APPLICATION FOR SUBMITTAL OF POST-APPROVAL DOCUMENT

2. PROJECT INFORMATION:			
School District/Owner: <u>Bakersfield City School District</u>		DSA File Number: <u>15 6</u>	
Project Name/School: <u>Dr. Martin Luther King Jr. Elementary School</u>		DSA Application Number <u>03 122605</u>

ADDENDUM NO. 2
PROJECT MANUAL
MLK ELEMENTARY SCHOOL
WELLNESS CENTER
BAKERSFIELD CITY SCHOOL DISTRICT

Project No.: 5527
DSA File No. 15-6
DSA App No. 03-122605
December 19, 2024

Sheet No.:
A5.11

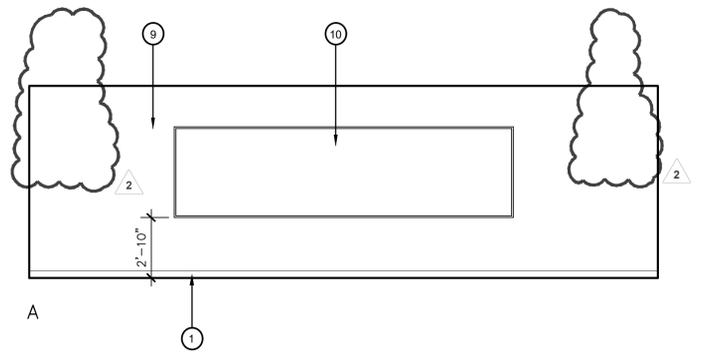
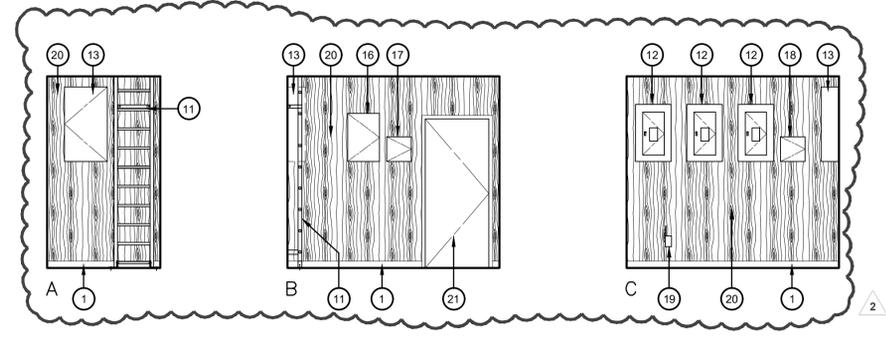
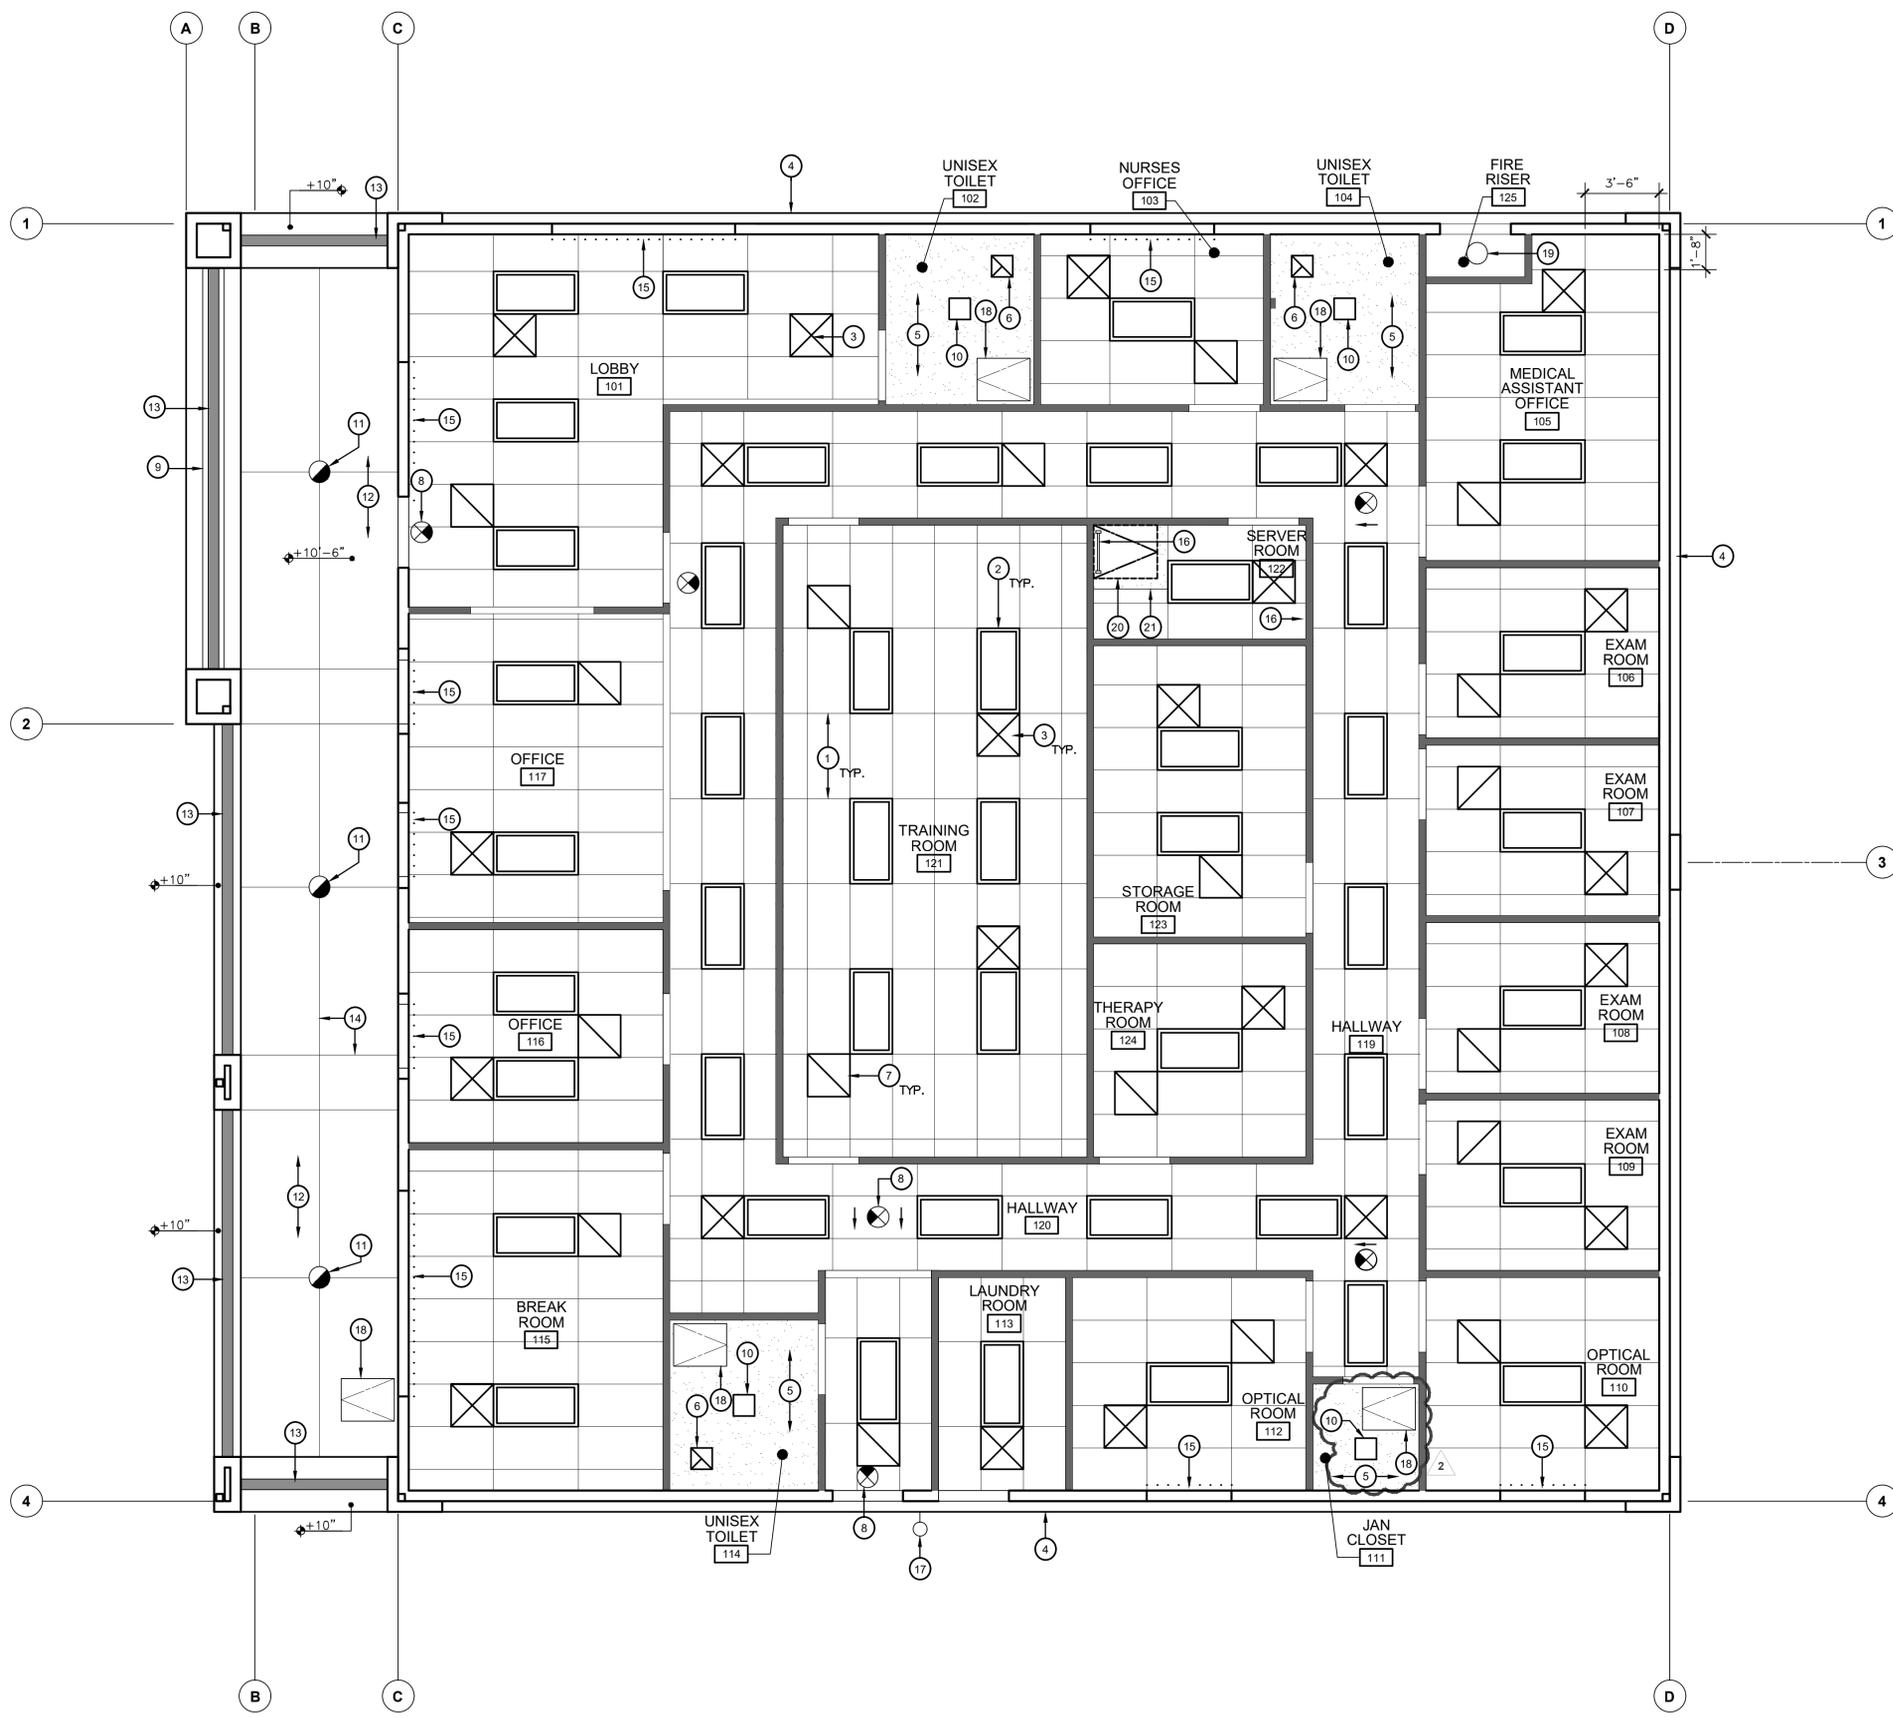
2-16 DRAWING, SHEET A5.11 – INTERIOR ELEVATIONS: Note the following changes (see A5.11 addendum 2 drawing):

1. Delete TVs from training room 121.
2. Electrical server room 122.
 - i. Add elevations B and C
 - ii. Modify elevation A.
3. Elevation “B” therapy room 124
 - i. Add TV. See keynote 7.

6 DET. AT PIPE PENETRATION
ADR100-02 SCALE: 1" = 1'-0"

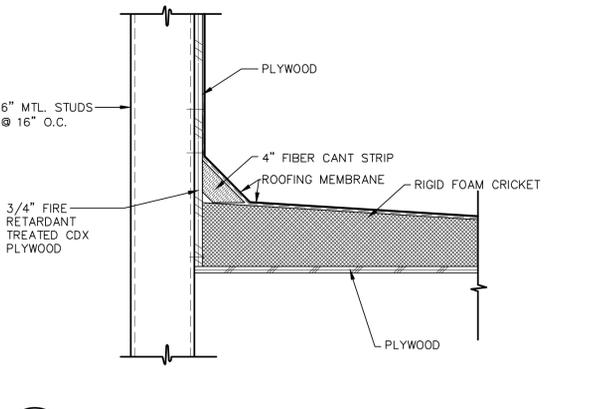
2-18 DRAWING, SHEET 7.02 – EXTERIOR DETAILS: Note the following changes (See A7.02 addendum 2 drawing):

1. Replace roof drain details 2/A7.02 and 3/A7.02.
2. Add pipe penetration detail 6/A7.02

Sheet No.:
A7.03

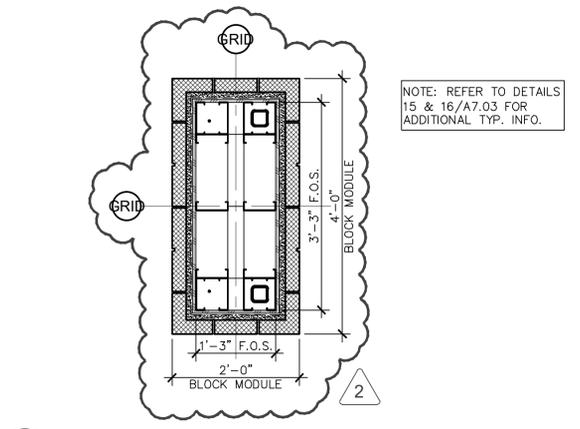
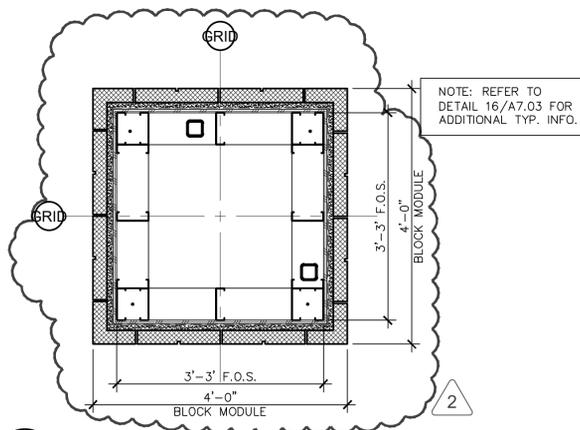
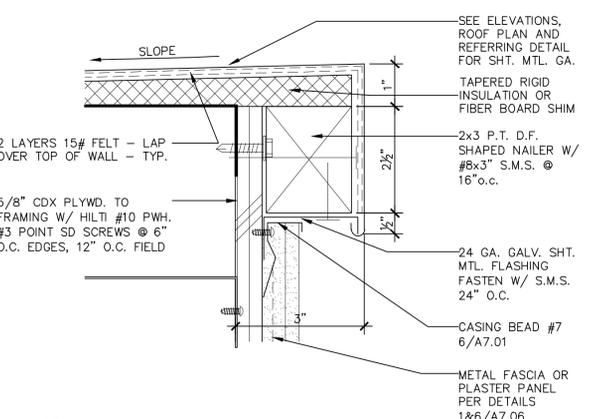
2-19 DRAWING, SHEET A7.03 – EXTERIOR DETAILS: Note the following changes (See A7.03 addendum 2 drawing):

1. Details 9, 10, 11 and 12 have new dimensions and show correct locations of the steel columns.

Sheet No.:
S2.01

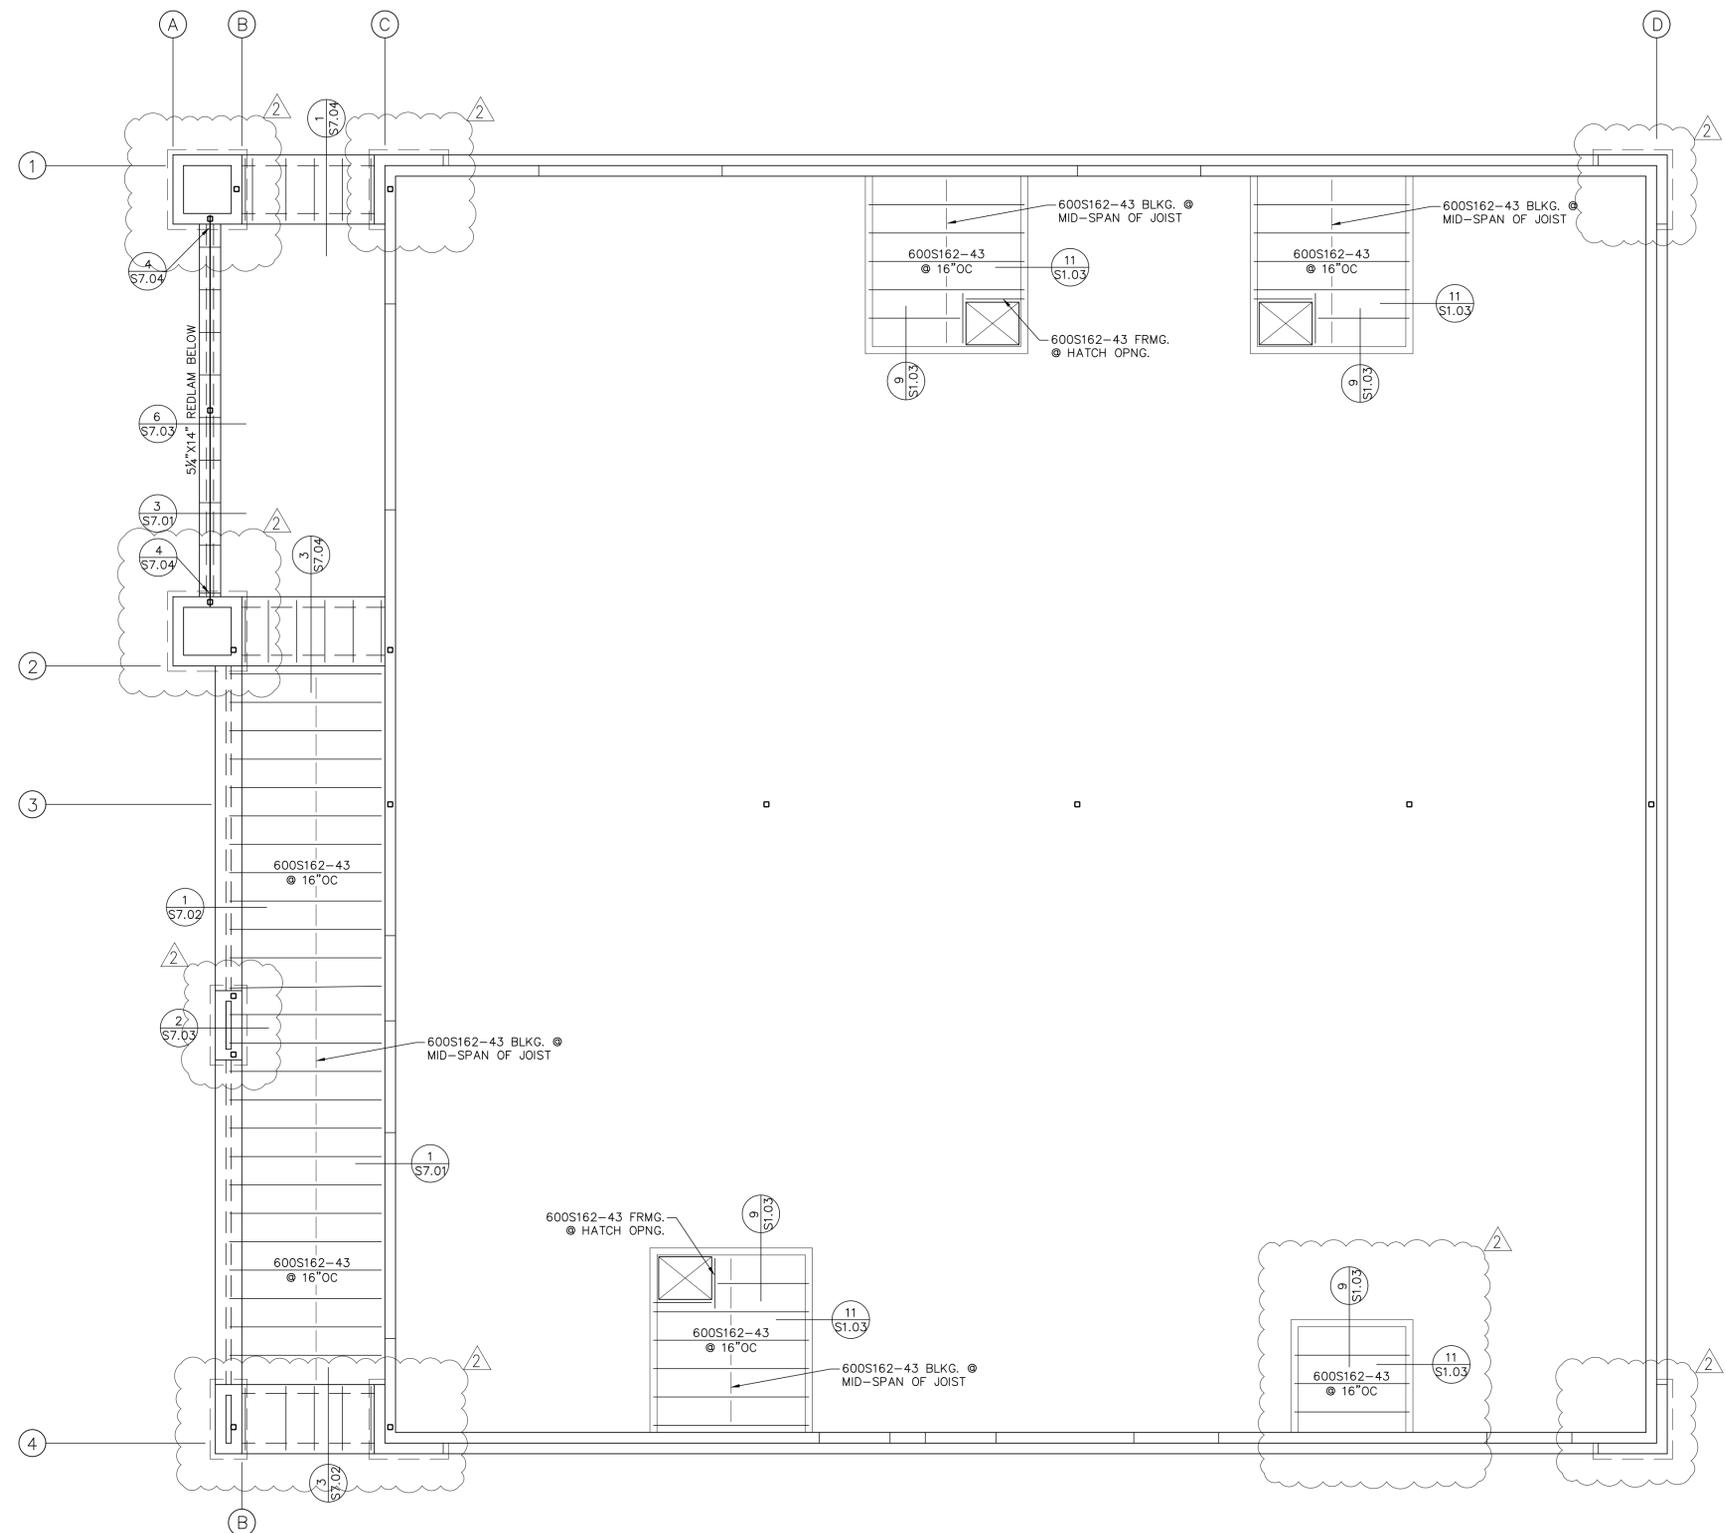
2-20 DRAWING, SHEET S2.01 – FOUNDATION PLAN: Note the following changes (See S2.01 addendum 2 drawing):

Sheet No.:
S3.01

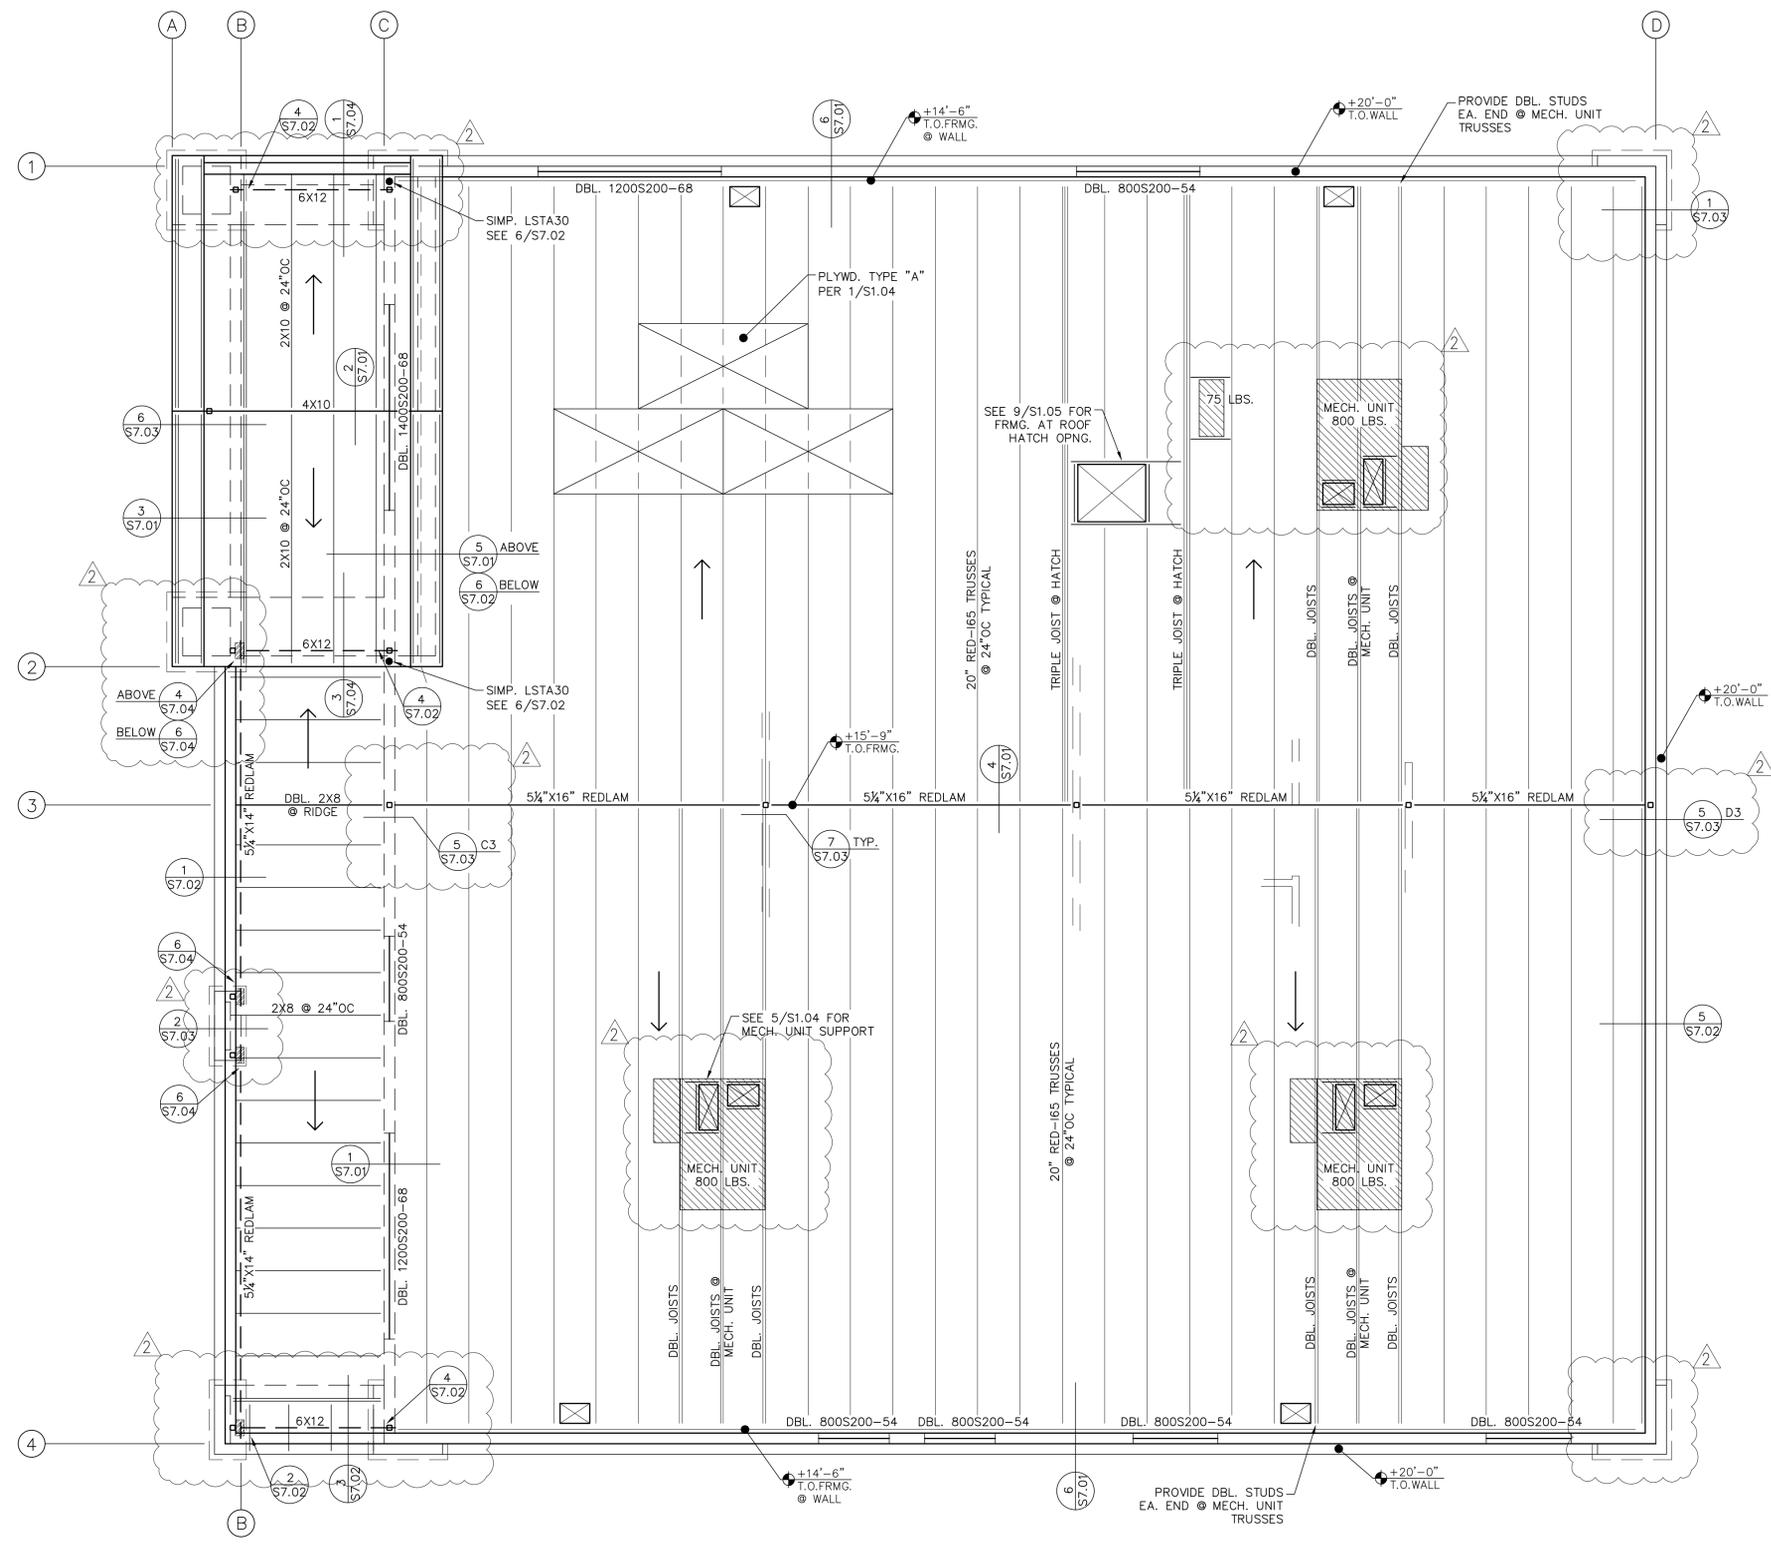
2-21 DRAWING, SHEET S3.01 – CEILING FRAMING PLAN: Note the following changes (See S3.01 addendum 2 drawing):

1. Add attic access door framing in janitor's room.
